**Kansas Department of Agriculture**  
**Division of Water Resources**  
APPROVAL OF CHANGE APPLICATION WORKSHEET

1. File No.: <b>50,584</b>		2. Status Change Date:		4. Field Office: <b>02 - Stafford</b> GMD: <b>02 - Equus Beds</b> Structures File No.: Filing Date: <b>02/26/2025</b>

**DWR FIELD OFFICE  
APPLICATION FOR APPROVAL  
TO CHANGE THE PLACE OF  
USE AND/OR THE  
POINT OF DIVERSION**

**EQUUS BEDS GROUNDWATER MANAGEMENT DISTRICT NO. 2  
FINAL APPLICATION REVIEW CHECKLIST**

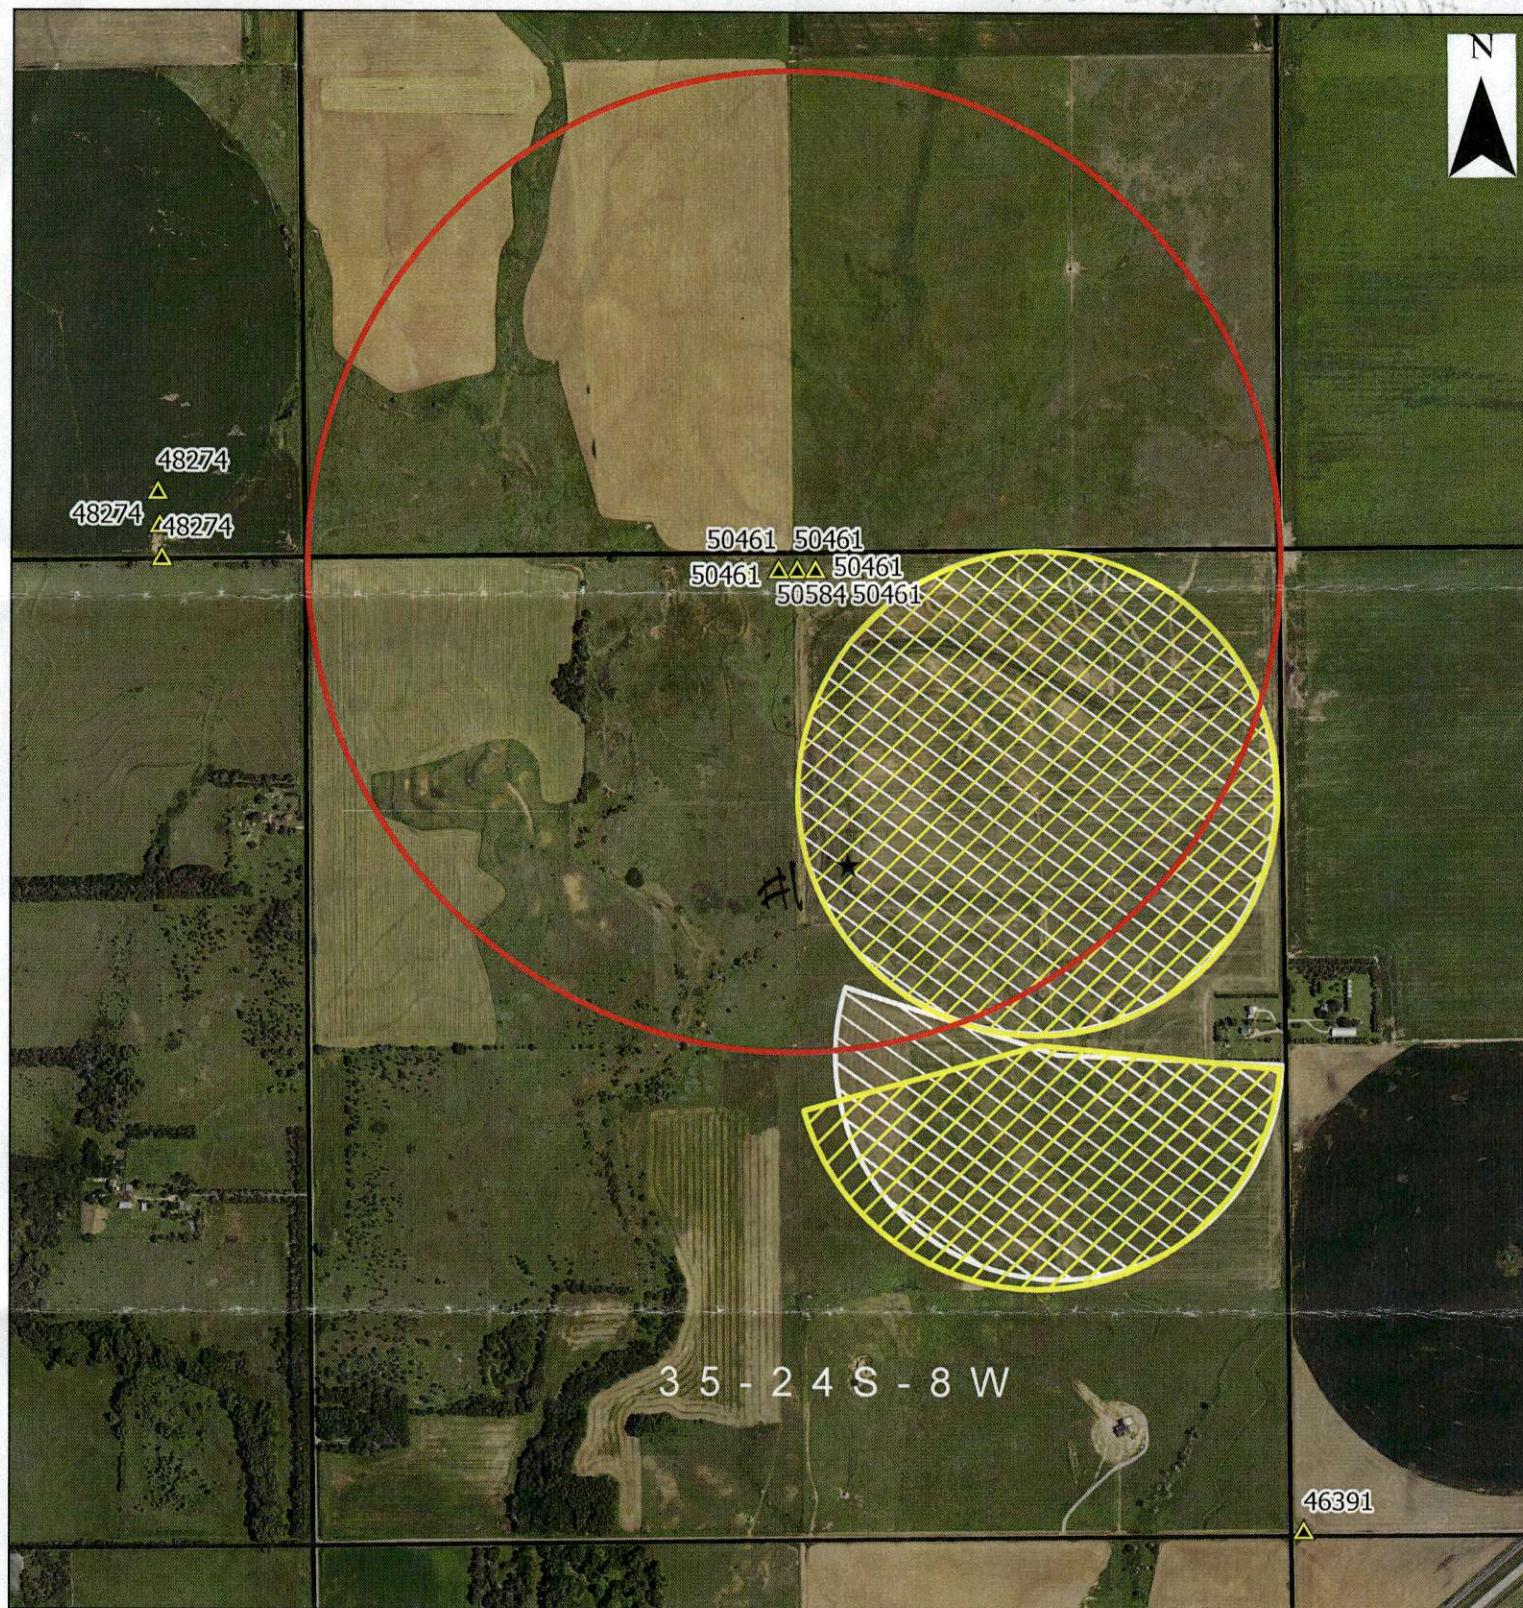
I declare that all water wells or diversions sites using the same source of supply and within 1/2 mile of the proposed point of diversion have been plotted on the application map. \*See Attached page for names and addresses

#1 Domestic well  
Applicants stock well

2. On and after the effective date of this summary order, the authorized place(s) of use shall be located substantially as shown on the topographic map accompanying the application to change the place of use. ☒ Applicable ☐ Not Applicable

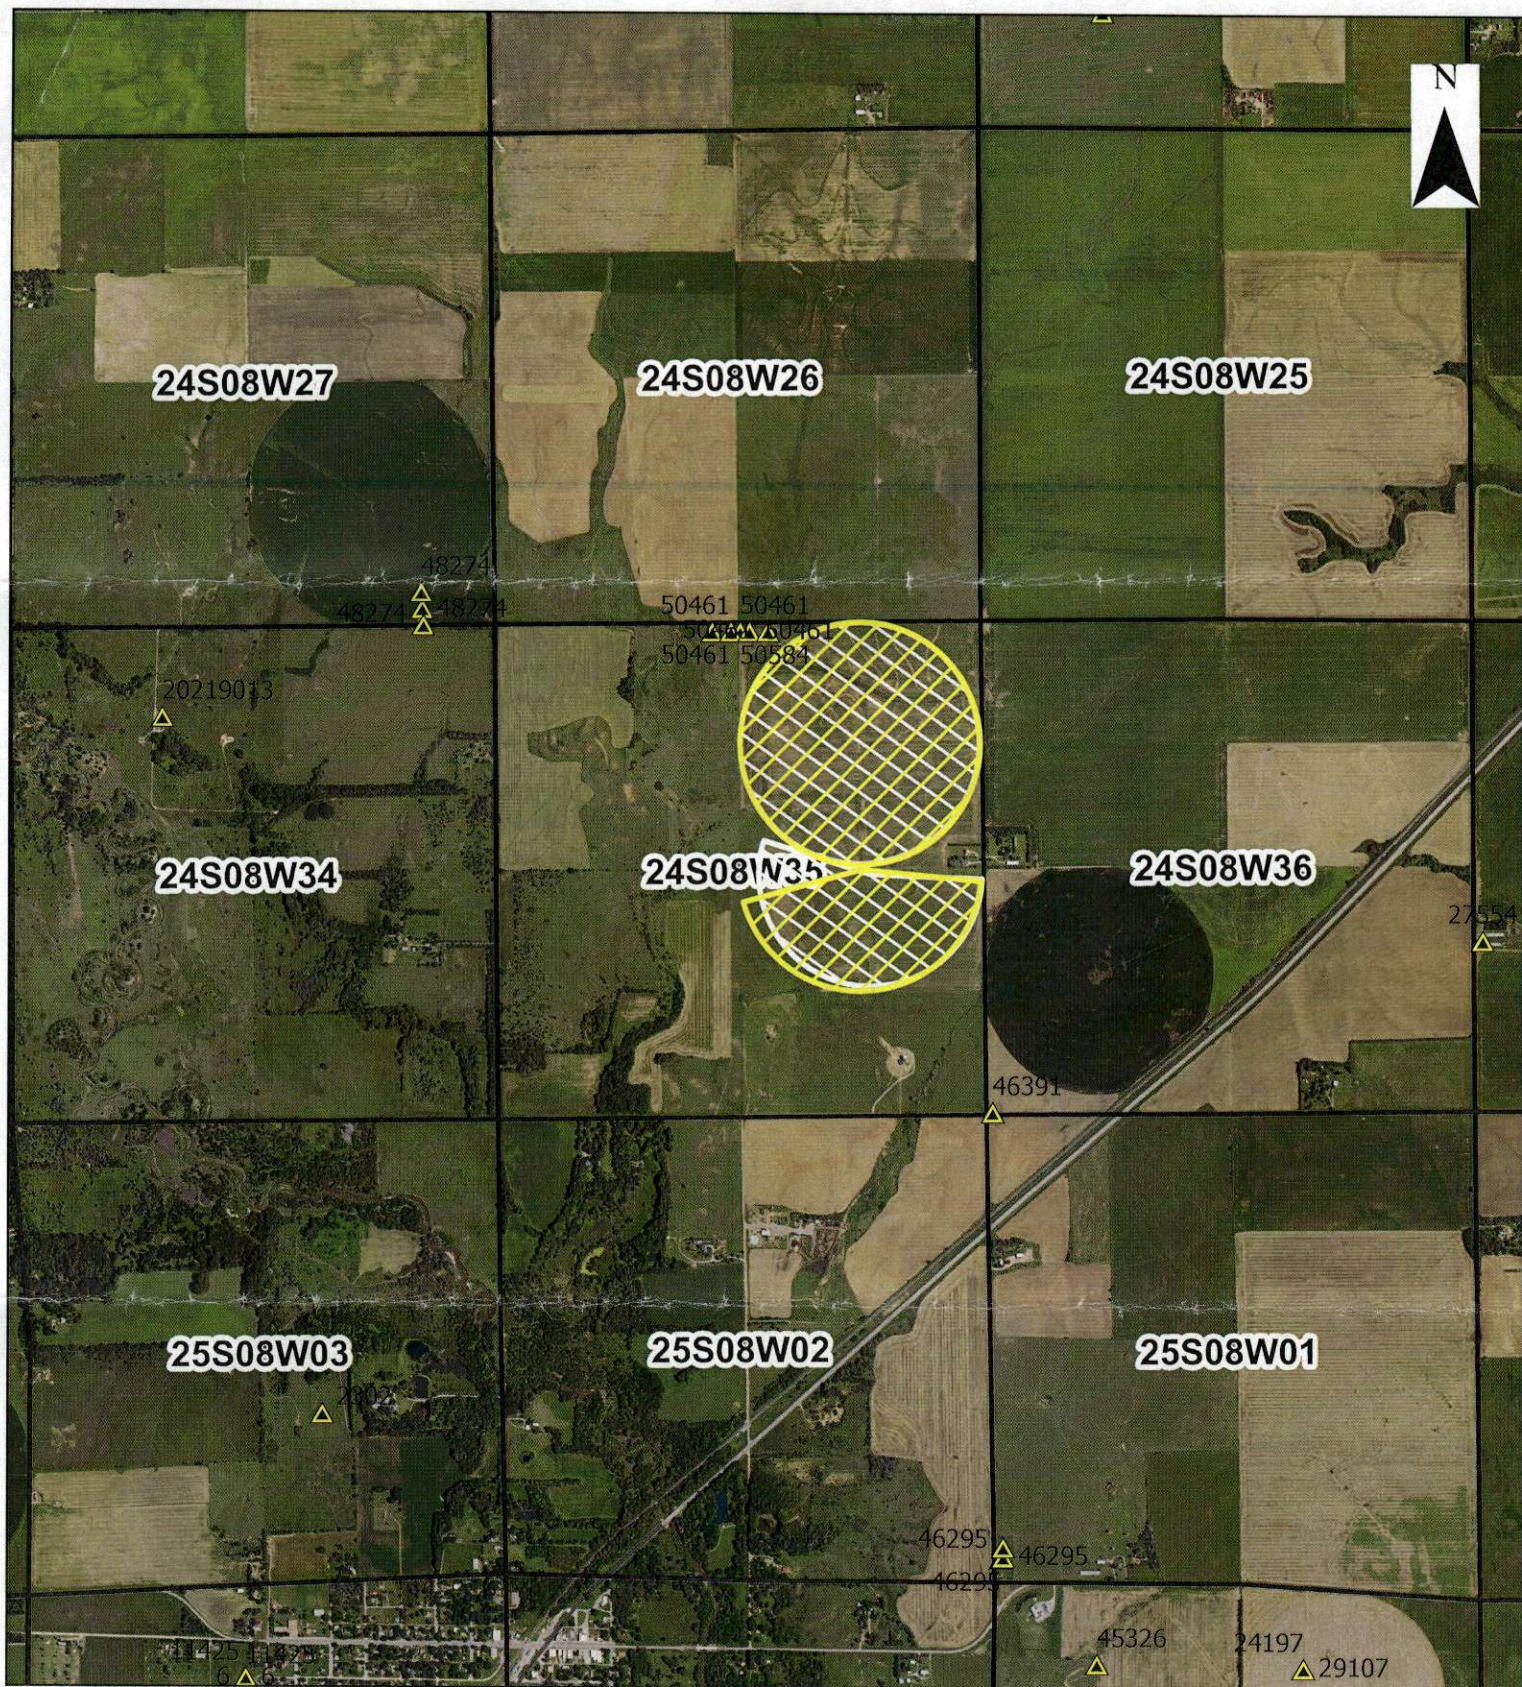
Change in place of use application submitted by Marvin Miller to modify the place of use and add 1.3 acres for a total of 179 acres in Reno County. PU is proposed to add 1.3 acres to the PU and form a complete and identical overlap in PD/PU with change in PU filed on No. 50584. The app. map shows the areas to be modified. Water Permit No. 50461 has not been perfected. PD will apparently be corrected with this change to a battery of three wells, as one well of the battery was not completed.

Application requests a change in place of use of the currently authorized acres and add 1.3 acres for a total of 179 acres. Base acres for No. 50461 & 50584 is 177.7 total acres. Proposed increase of 1.3 acres (less than 1%) complies with K.A.R. 5-5-11 max increase of 10 acres/10% (whichever is less).

Recommend approval, complies with K.A.R. 5-22-1 through 5-22-17.
